PCN-20190829 TEI0009-02 Under Voltage Protection Change

| Title | TEI0009-02 Under Voltage Protection Change |
| Subject | Trenz Electronic TEB0724 Hardware Change |

#1 Replaced R27 by 953kOhm and R32 by 147kOhm

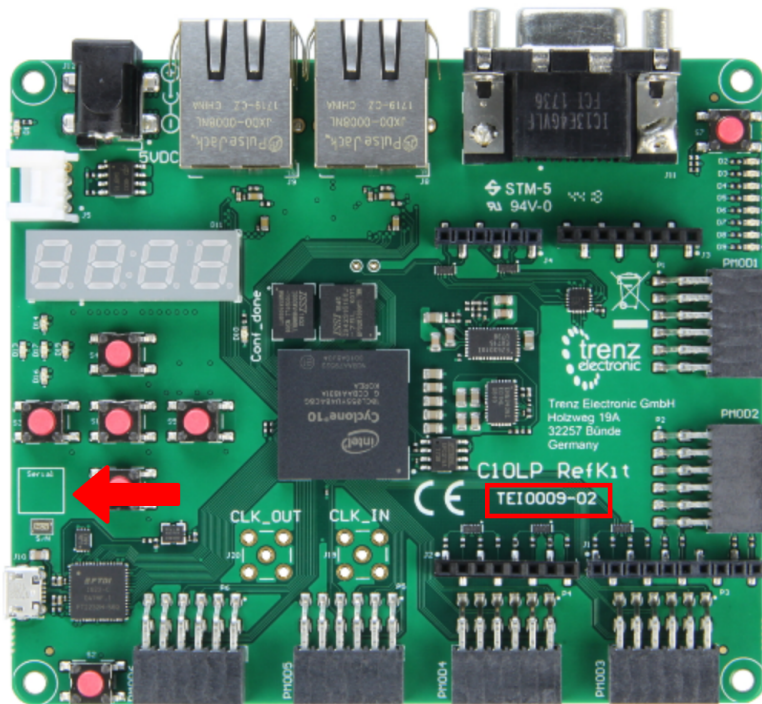
Reason: Large start up currents led due to adverse conditions (e.g. weak powersupply, long wires, increased contact resistance) to a voltage drop below the under voltage lock out limit of the input protection circuit.

Type: BOM change

Impact: Under voltage protection limit is decreased to 4.06V, which gives a larger margin for a voltage drop during start up.
